FW: LRB 18/00038/RREF Application 18/00956/FUL - land NW of Chapel Cottage

Subject: RE: LRB 18/00038/RREF Application 18/00956/FUL - land NW of Chapel Cottage

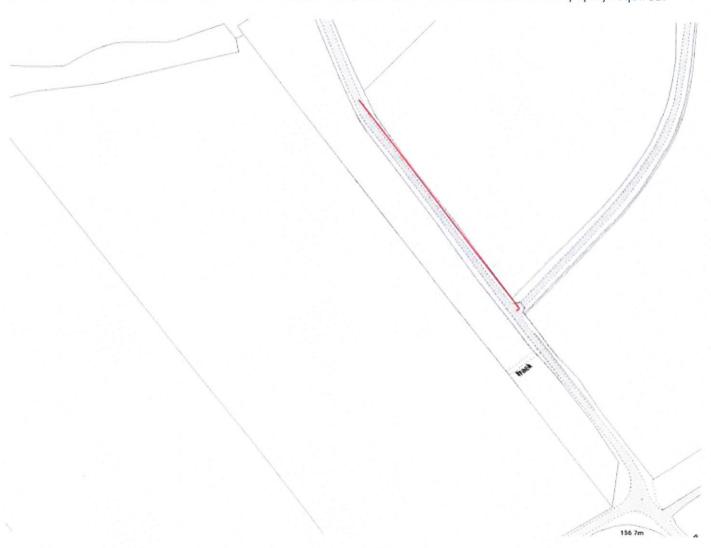
With regards the amended detail supplied and included on page 65, the plan submitted is not realistic to the actual layout on the ground. Their plan implies that the road is straight, whereas in reality the road curves to the east at the northern end. I have shown below a more realistic impression of the 2.4m x 160m visibility splay required.

That said, I am satisfied that satisfactory visibility can be provided in that direction, particularly now that the hedge has been removed over the initial site boundary.

Visibility splays of $2.4m \times 90m$ to the left and $2.4m \times 160m$ to the right (on exiting) must be provided at the junction with the B6359 prior to commencement of development and maintained thereafter in perpetuity.
